MONTGOMERY COUNTY HISTORIC PRESERVATION COMMISSION
STAFF REPORT

Address:	23 Hesketh Street, Chevy Chase	Meeting Date:	1/21/2026
Resource:	Contributing Resource Chevy Chase Village Historic District	Report Date:	1/14/2026
Applicant:	Susie and John Lively (Thomas Hazzard, Agent)	Public Notice:	1/7/2026
Review:	HAWP	Tax Credit:	No
Case Number:	1145082	Staff:	Laura DiPasquale
Proposal:	Construction of front portico and new rear screened porch

Staff recommends that the HPC **approve with one (1) condition** the HAWP application, with final approval authority delegated to staff:

Figure 5: Detail of the rear addition and porch approved by the HPC in 2012.

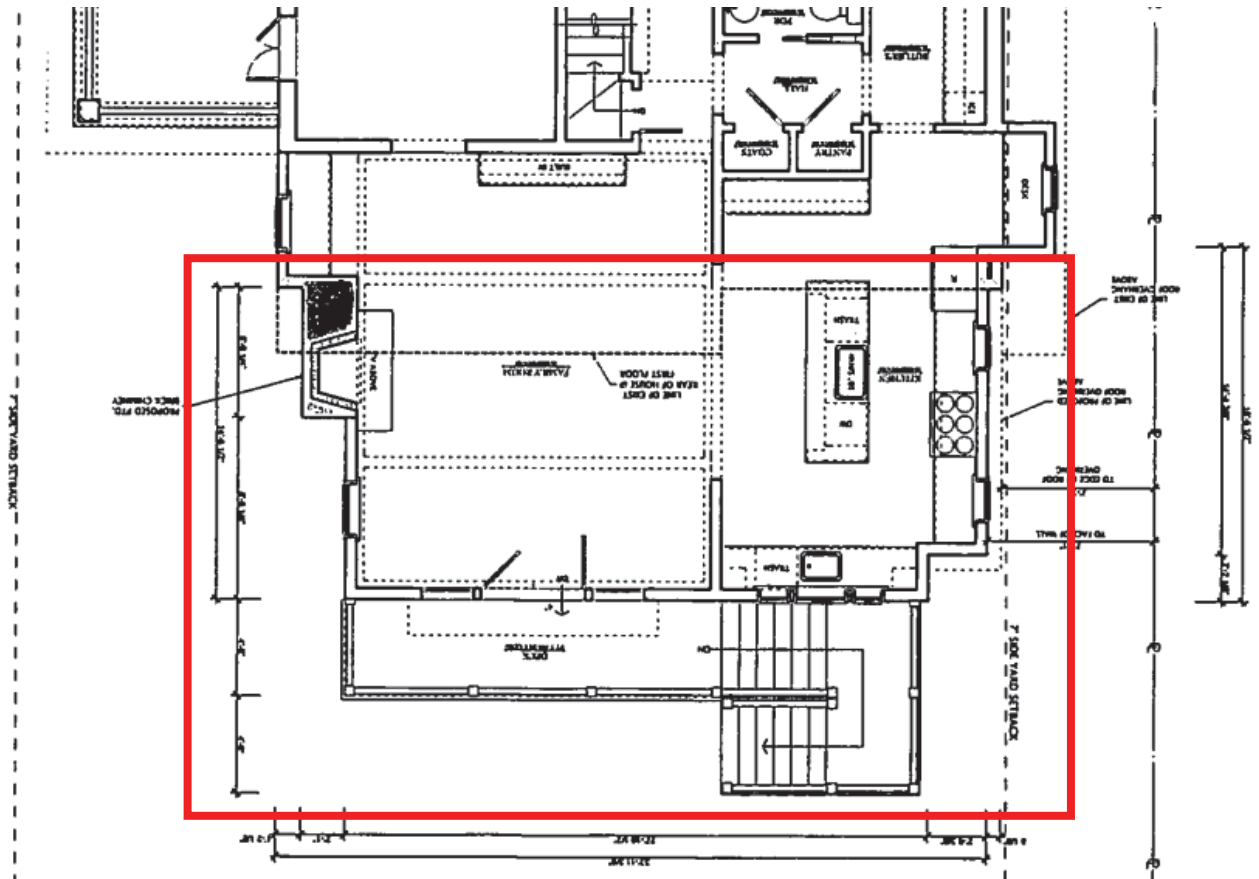
In 2012, the HPC reviewed and approved construction of a two-story rear addition at the subject property.¹ The current proposal modifies that addition, removing the existing open porch and replacing it with a larger screened porch, open grill deck, and stair to grade. Staff finds that the proposed alterations are located at the rear of the property with limited visibility from the public right-of-way and exclusively alter non-historic materials, in keeping with the *Guidelines*, Chapter 24A-8(b)(1) and *Standards 2 and 9*.

Figure 6: Detail of the proposed rear screened porch, deck, and stairs.

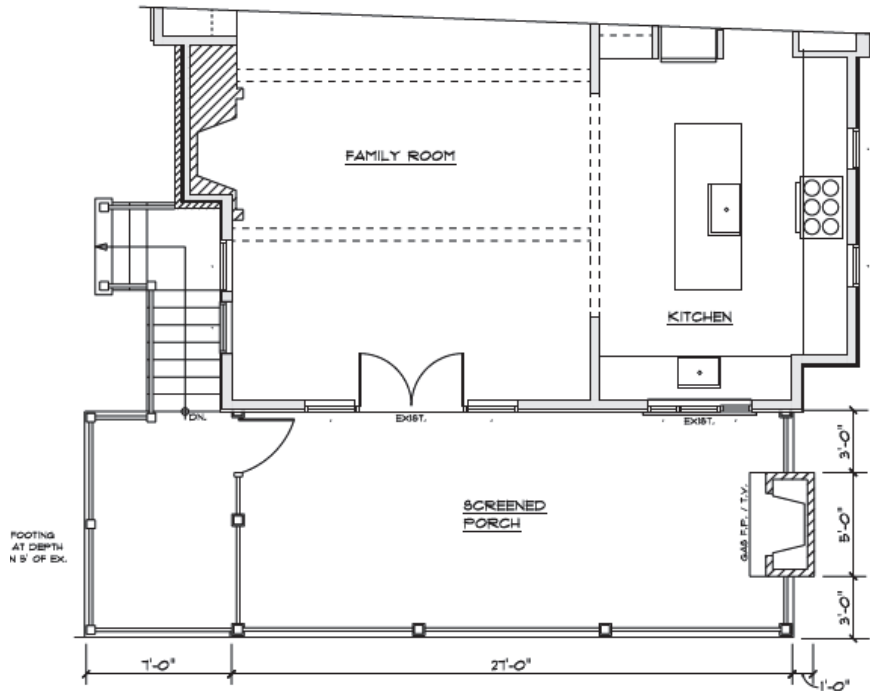
Staff notes that the drawings indicate that the steps to grade, which have the highest potential for visibility from the public right-of-way, are noted as wood, but the decking itself is not specified. Staff finds that the screened porch will not be visible from the public right-of-way and that wood or a substitute material may be used for the screened porch per *Policy 24-01*. Staff recommends that the HPC condition the application on submission of final materials specifications to staff to confirm that the decking meets *Policy 24-01*. All trim is noted in the written scope as being painted wood, which staff finds is appropriate under Chapter 24A-8(b)(2).

1. The proposed deck and porch flooring must meet *Policy No. 24-01*. The applicant must provide final materials specifications to staff.

SITE PLAN
SCALE: 1" = 10'

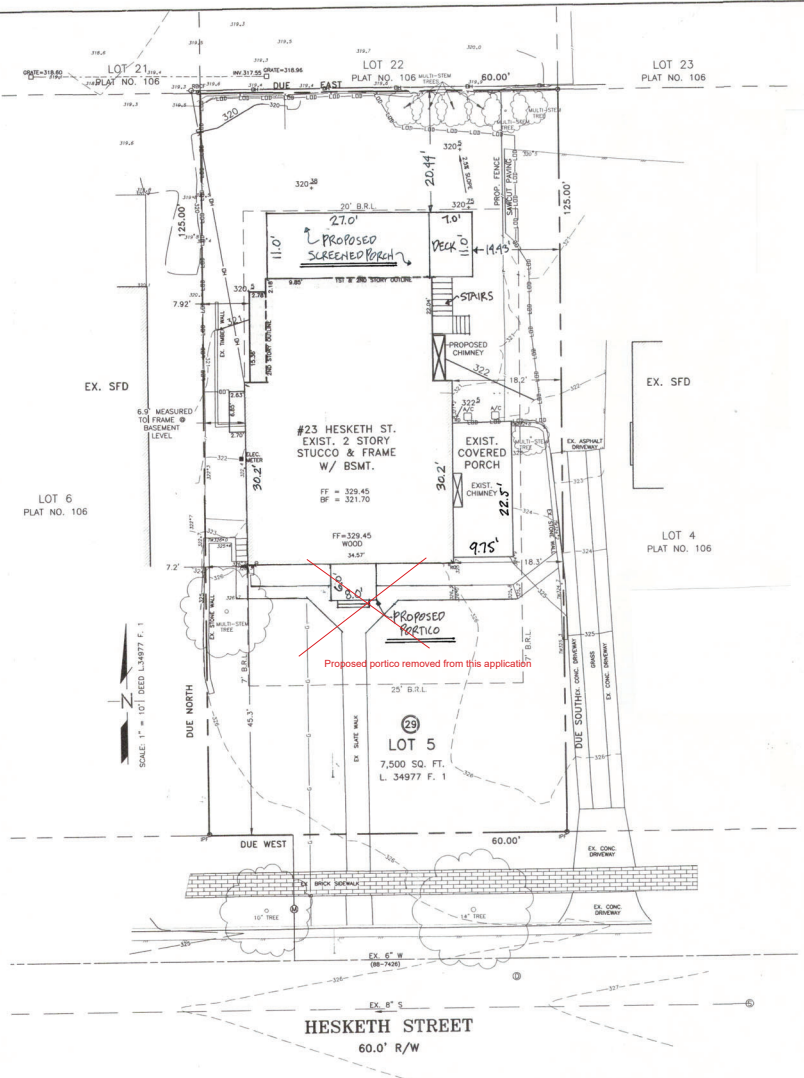
Visible inspection of the property clearly indicates the grading slopes north and away from Hesketh St. Any increase to the impervious area would possibly have an impact on the adjacent property on W Irving St or result in ponding in the rear yard. Going over the provided lot and impervious coverage calculations and confirmed with field measurements, it appears that all proposed improvements in the rear yard would result in a decrease of 101.5 SF of impervious surface. The only increase based on their calculations would be an increase of 56 SF to the front portico, which would still have a total decrease of impervious surface of 45.6 SF.

The design appears to be decreasing the impervious footprint of the property. There should be minimal impact to adjacent properties for the increase in the impervious area. Based upon this information 20 Grafton St.'s building permit shows compliance with Section 8-25 of the Village Code.
